GFA AD 563
(ISSUE 1)

GFA AIRWORTHINESS DIRECTIVE

TYPE AFFECTED: Diamond Aircraft :-
H-36 Dimona, serial numbers 36.220 and up (all Dimona Mk II);
H-36 VT, all serial numbers;
HK-36 Super Dimona, all serial numbers;
HK-36 R Super Dimona, all serial numbers;
HK-36 TS, all serial numbers;
HK-36 TC, all serial numbers;
HK-36 TTS, all serial numbers;
HK-36 TTC, all serial numbers;
HK-36 TTC-ECO, all serial numbers.

SUBJECT: Canopy locking mechanism.

Abbildung 1: Korrektes Einrasten der Blattfeder in der Nut
Figure 1: Proper Engagement of Leaf Spring in Groove

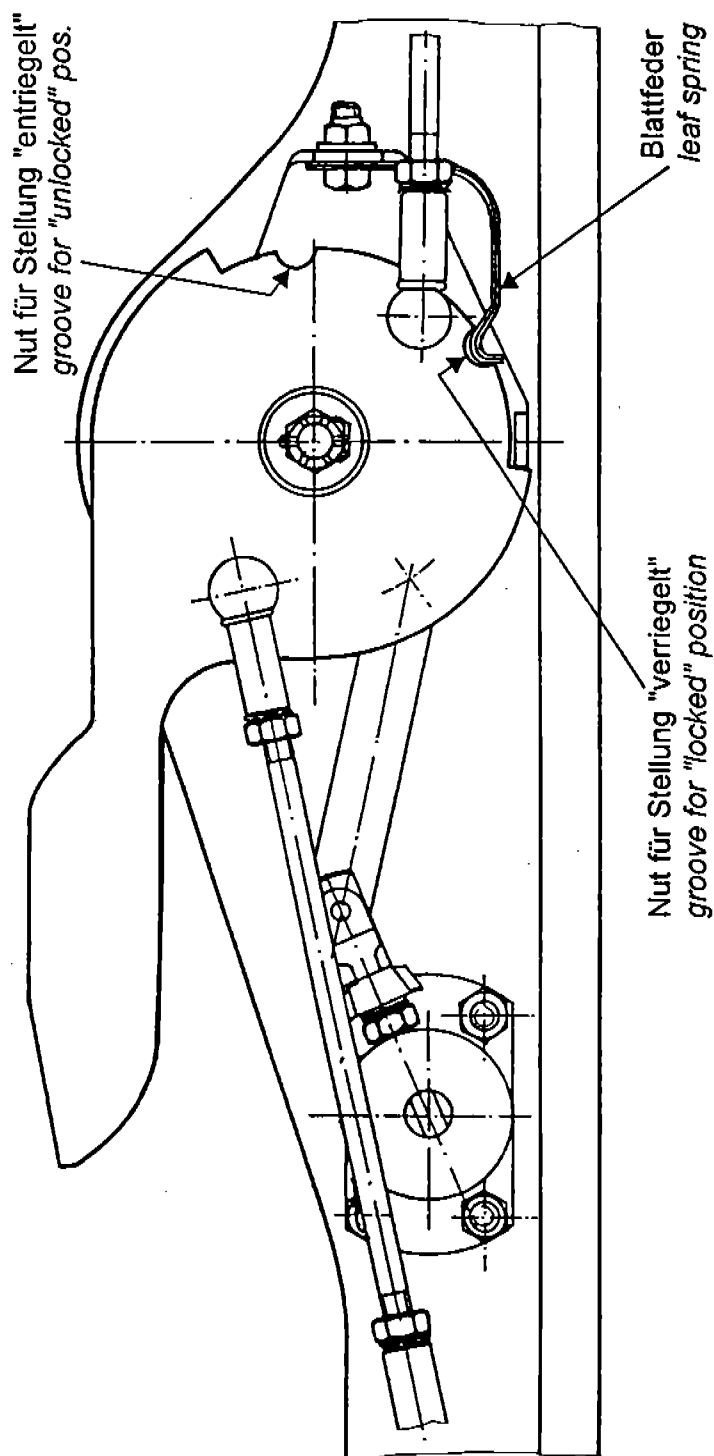
1. Inspection of canopy locking mechanism on both sides.
 - (a) Remove LH and RH cover (3 Phillips screws each).
 - (b) Check LH and RH locking mechanism for corrosion and insufficient lubrication. Also refer to Service Information No. SI36-004.
 - (c) Inspect LH and RH snap-in mechanism (see Fig. 1).
 - Check leaf spring and groove for wear.
 - Ensure by visual inspection that the spring engages in the groove completely when the red lever is in the "locked" (full forward) position. Snap-in must be noticeable when the canopy is open.
 - (d) Check lock wire for canopy jettison mechanism for damage.
 - (e) Ensure that the 4 locking bolts are not lubricated.
 - (f) Ensure that all 4 locking bolts protrude from the canopy frame contour by 2.5 to 3.5 mm (0.10 to 0.14 in) when the levers catch in the "unlocked" position (see Fig. 2).

Figure 3: Maximum Wear of the Bushes in the Canopy Frame in the Fuselage

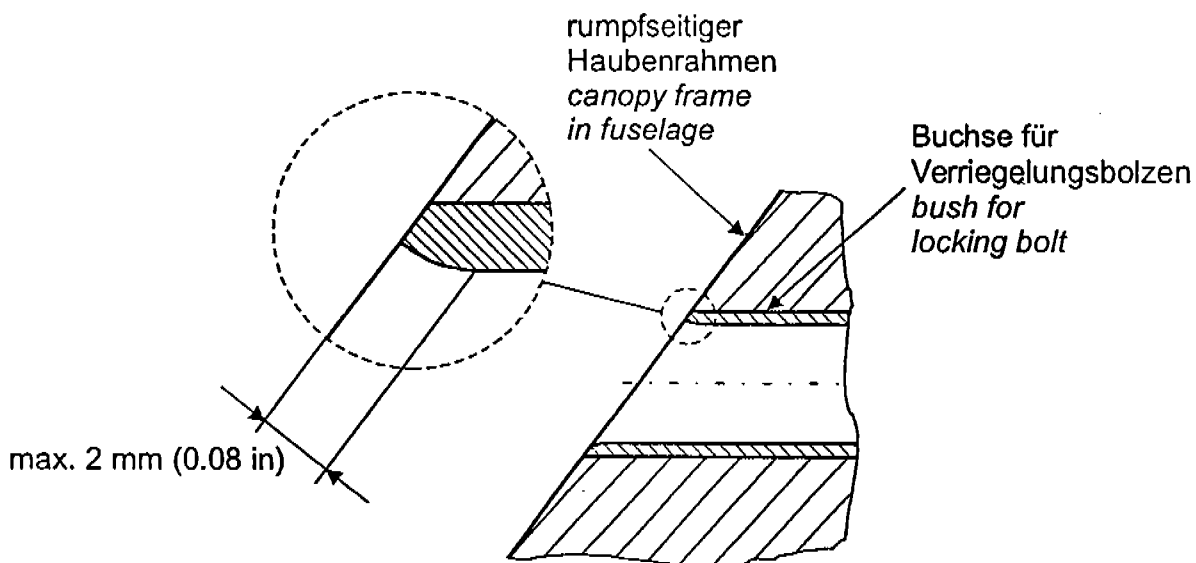
- (g) On the canopy frame in the fuselage: check bushes for all 4 locking bolts for excessive wear on the edge (max. 2 mm / 0.08 in, see Fig. 3). If necessary, replace bushes.
 - (h) Ensure that the LH and RH locking levers can be moved fully forward with the canopy closed (i.e., as far forward as with the canopy open). Verify proper engagement of the spring by visual inspection (see Fig. 1).
 - (i) Install cover.
2. The following placard (color: red) must be attached next to the ignition switch:
